# 100% CONSTRUCTION DRAWINGS

## CIMARRON HILLS SOUTHEAST MIXED USE FILING NO. 1

EPC STORMWATER REVIEW COMMENTS  
IN ORANGE BOXES WITH BLACK TEXT

<b>CIMARRON HILLS SOUTHEAST FILING NO. 1</b>			
EL PASO COUNTY, COLORADO SPRINGS			
<b>TITLE SHEET</b>			
DESIGNED BY: MDF	SCALE: HORIZ 1"=100'	DATE ISSUED: AUGUST 2024	DRAWING No. TS01
DRAWN BY: WCG	VERT. N/A	SHEET 01 OF 20	
CHECKED BY: NMS

DETENTION POND PLAN Pond 1  
H: 1"=40'

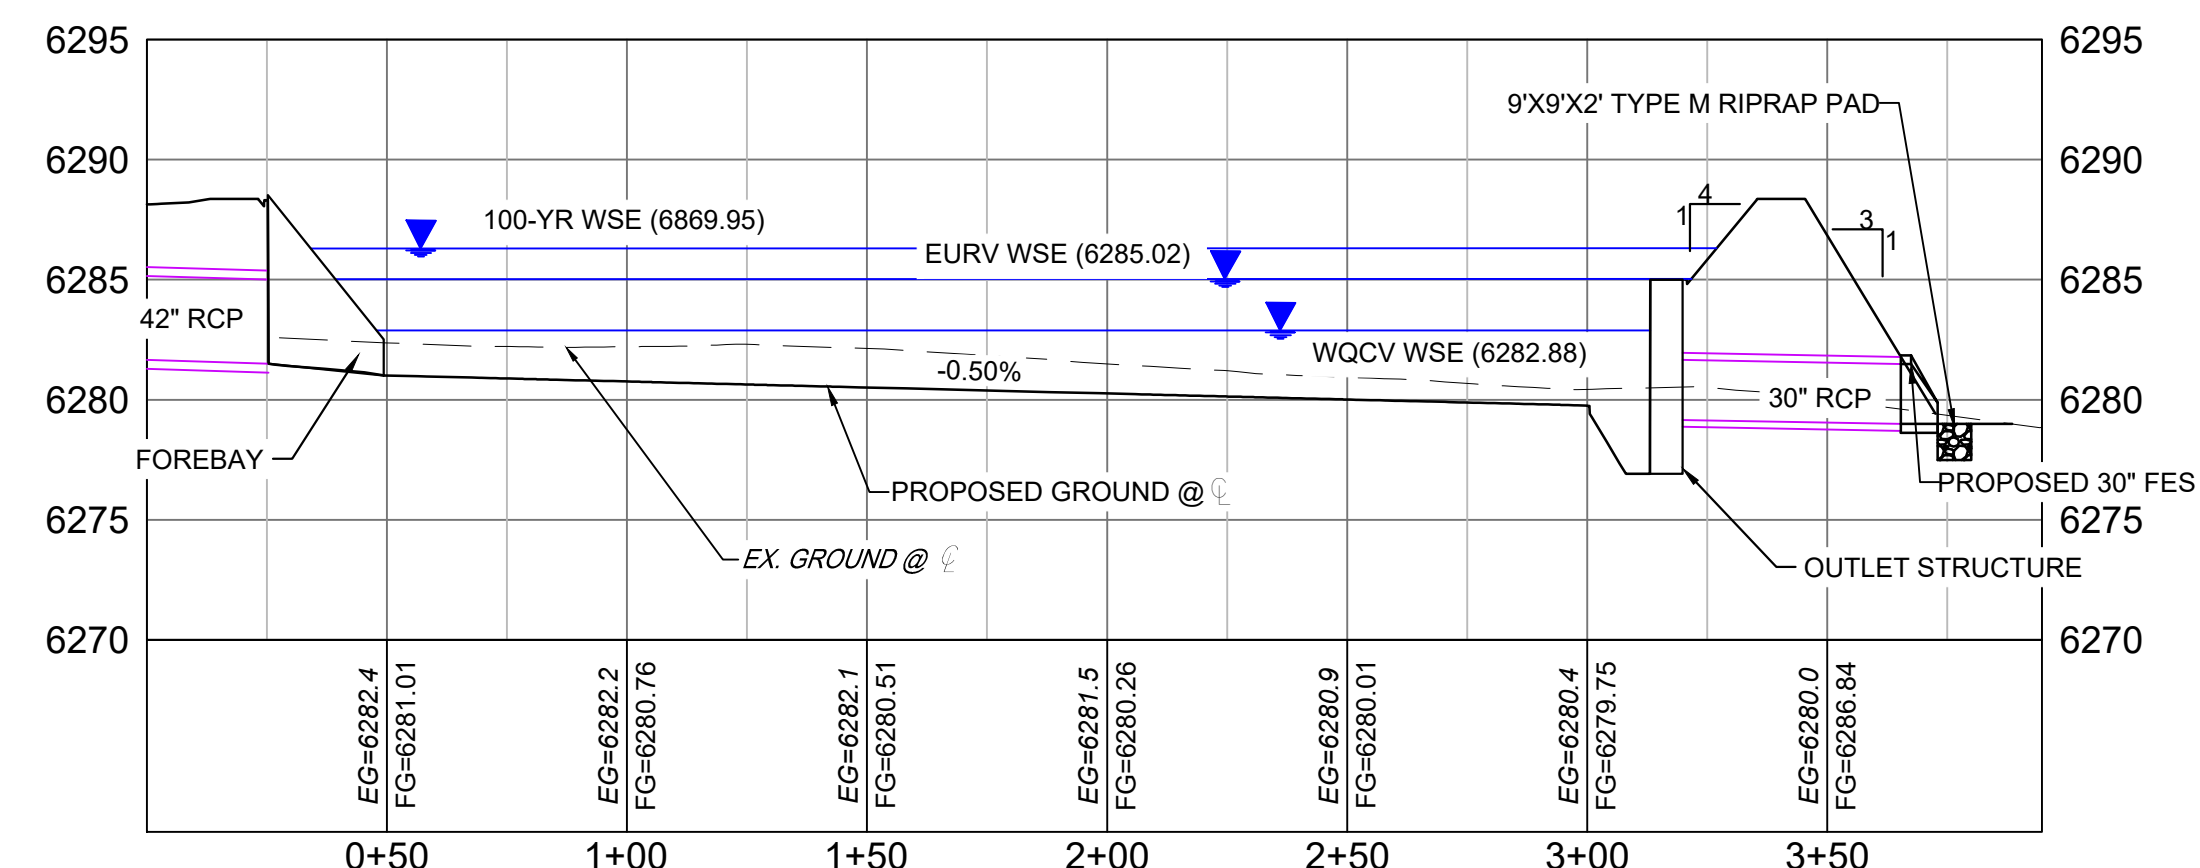
Stabilized access ramp shall be a minimum of 15ft wide and no greater than 12% slope, in accordance with DCMv1, Chap 11.2.2.

**PAVEMENT MARKING & SIGNING PLAN**

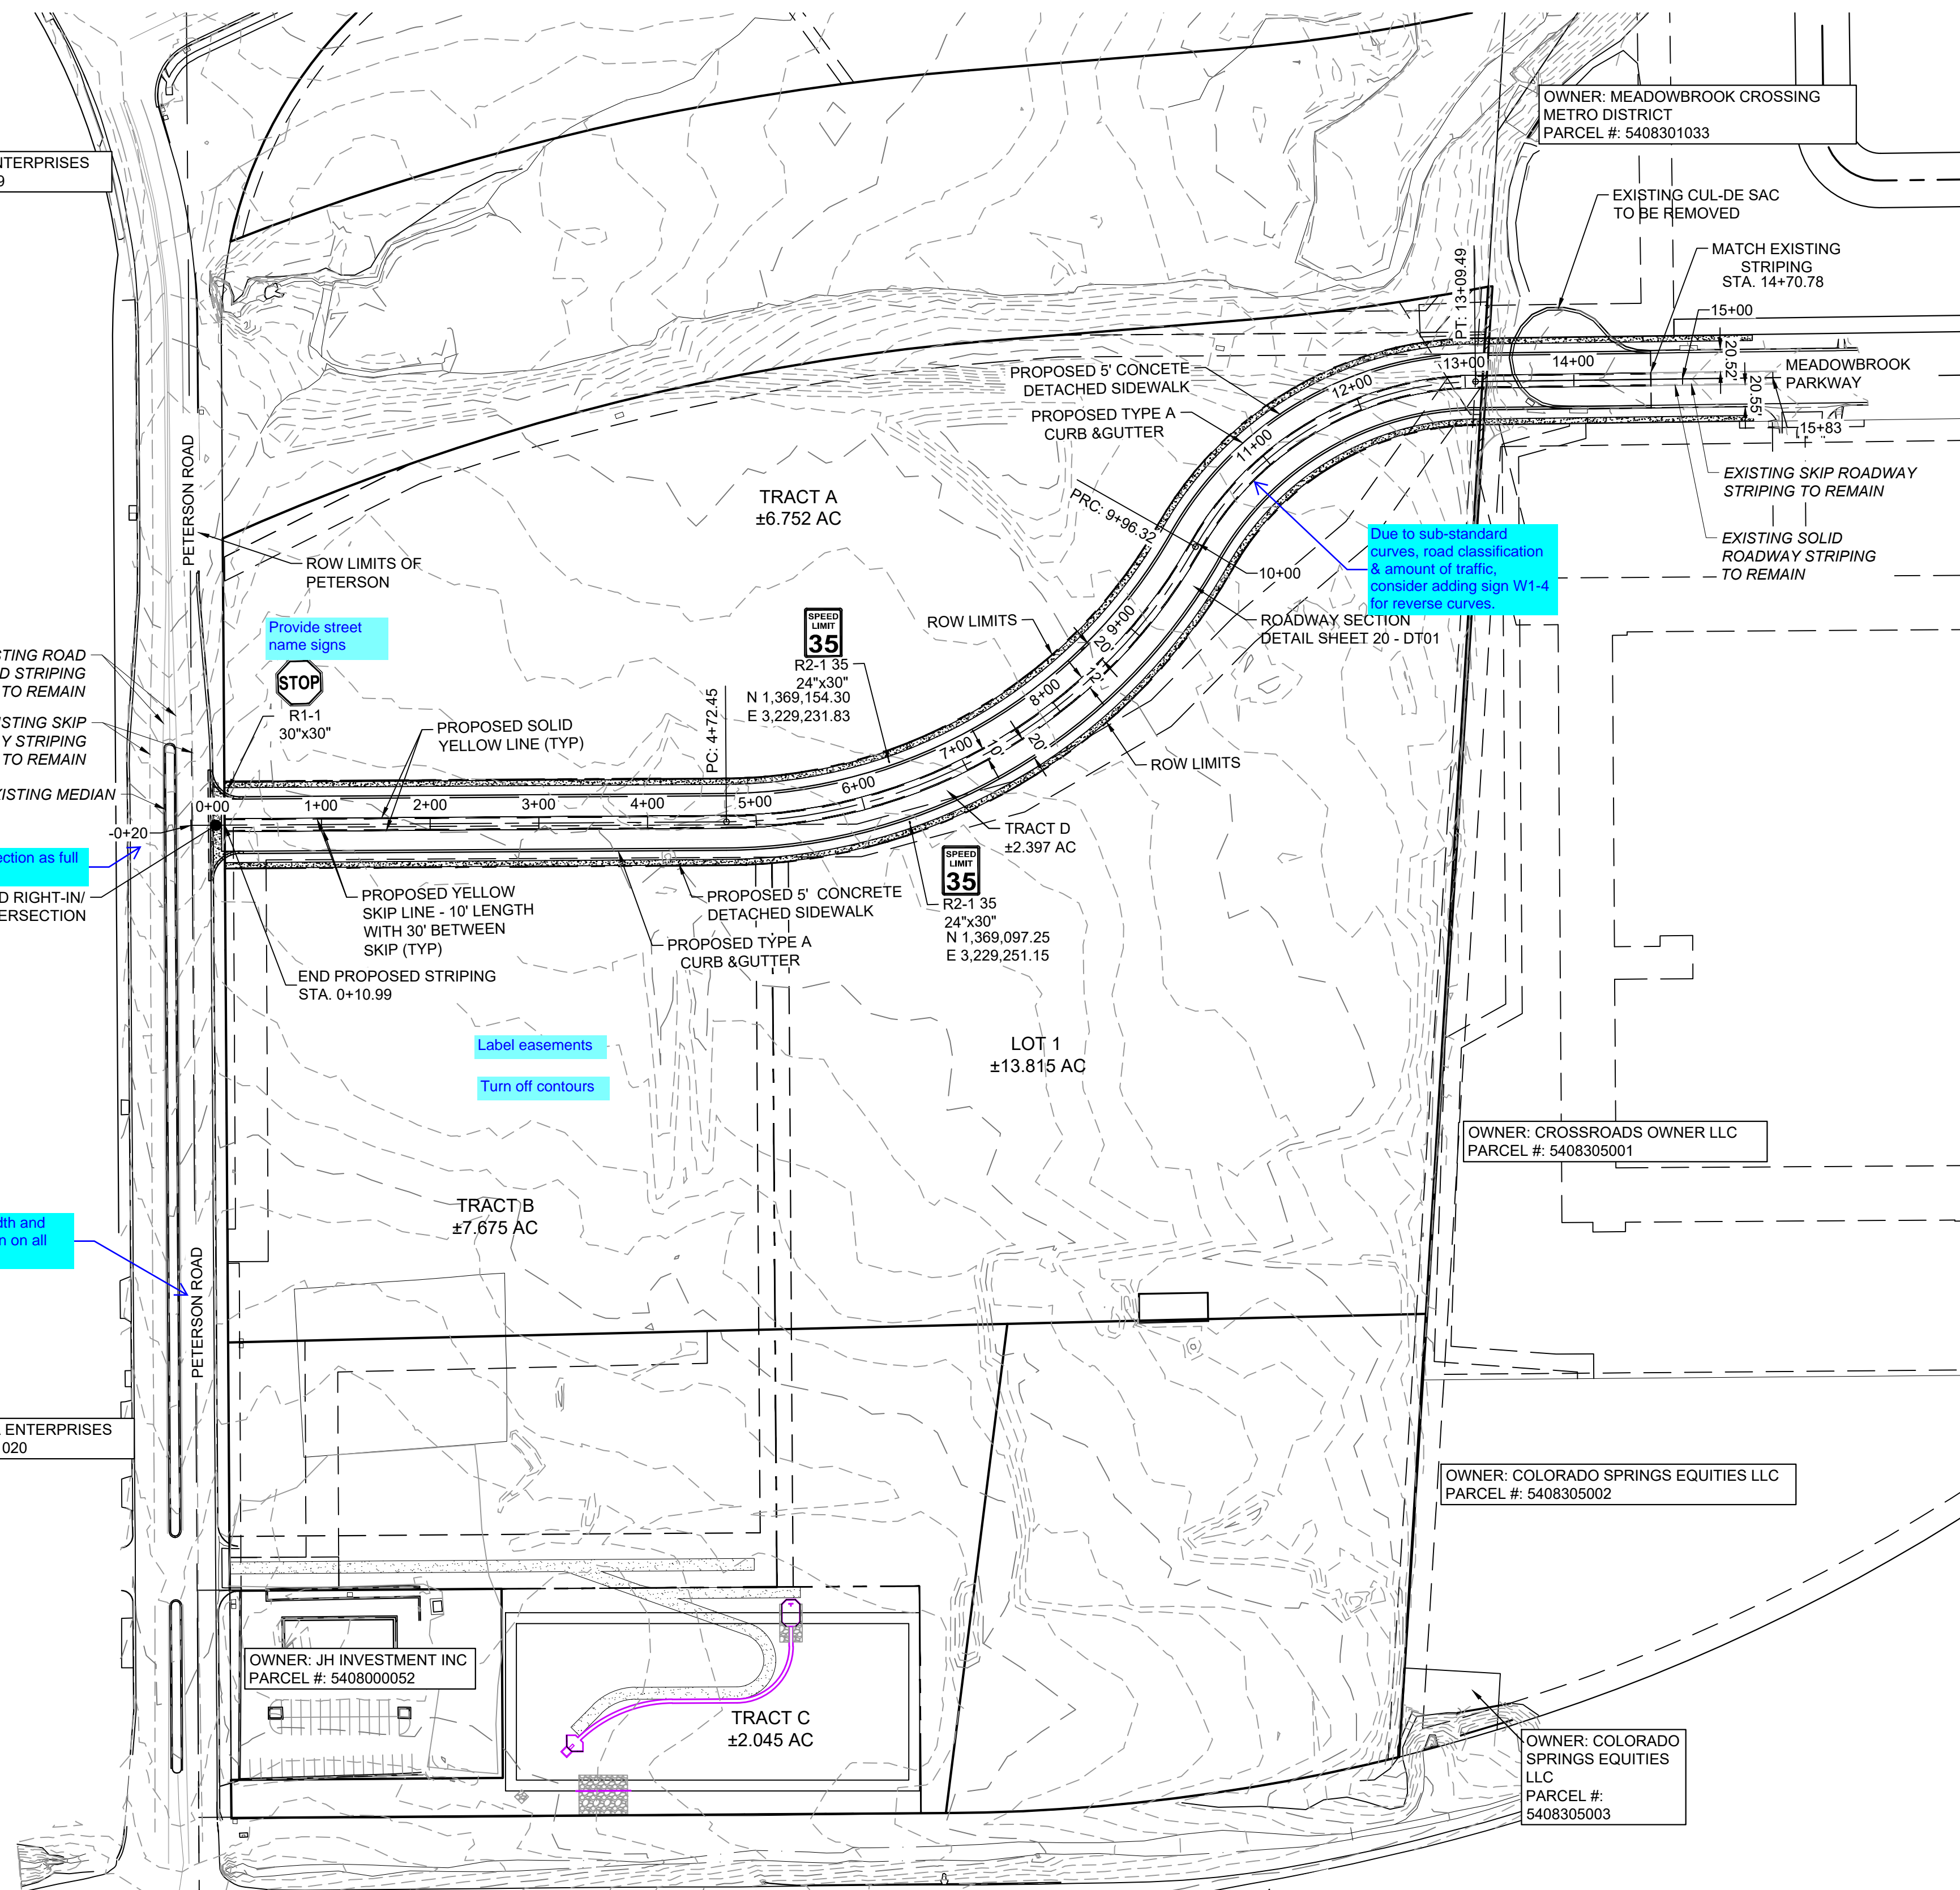
Notes only need to be in one location. If they are included on this sheet, they can be removed from sheet 2. Update to latest version of county signing & striping notes.

**SITE TRIANGLE**

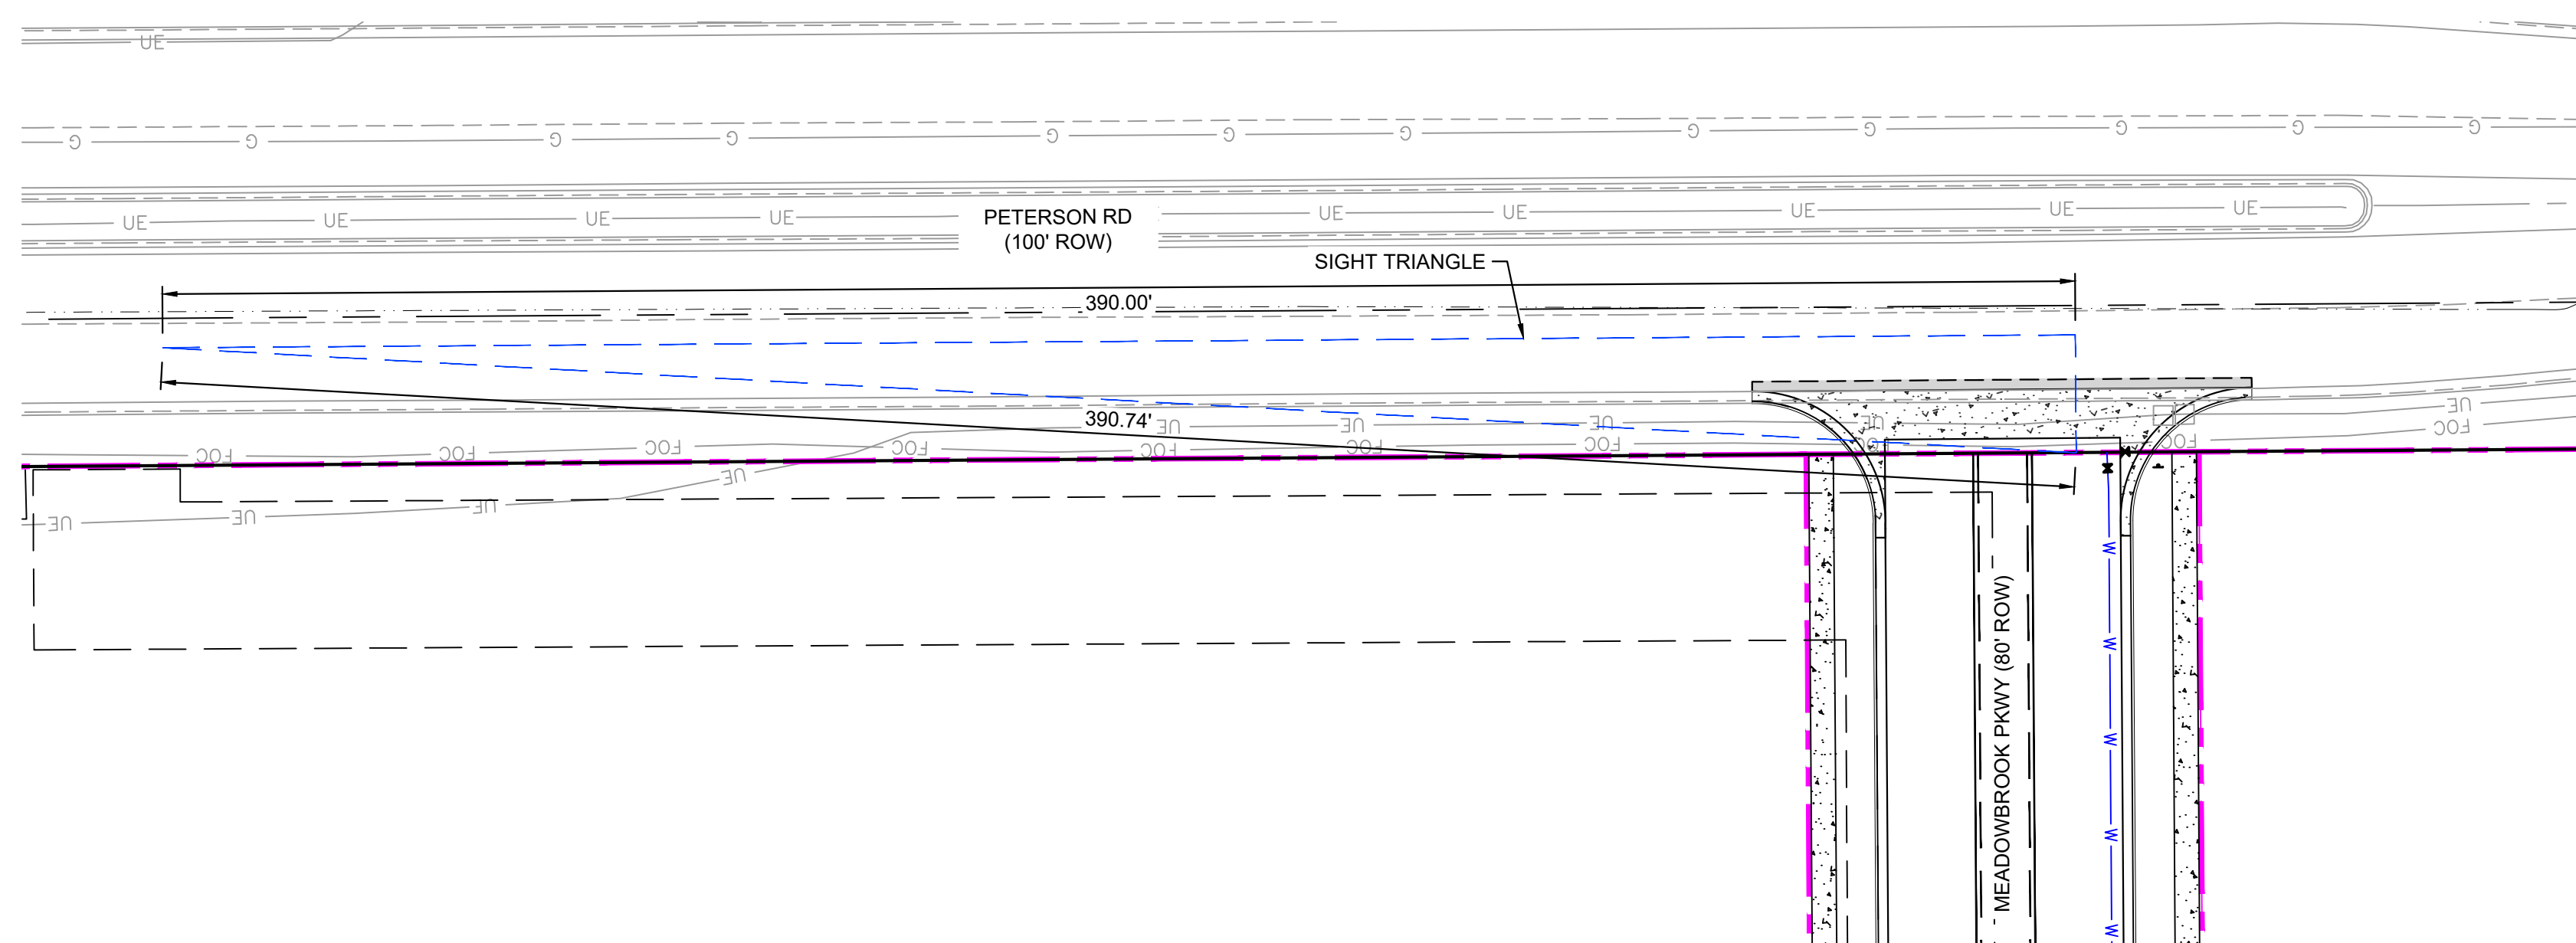
Provide site triangle for Lot 1 driveway.
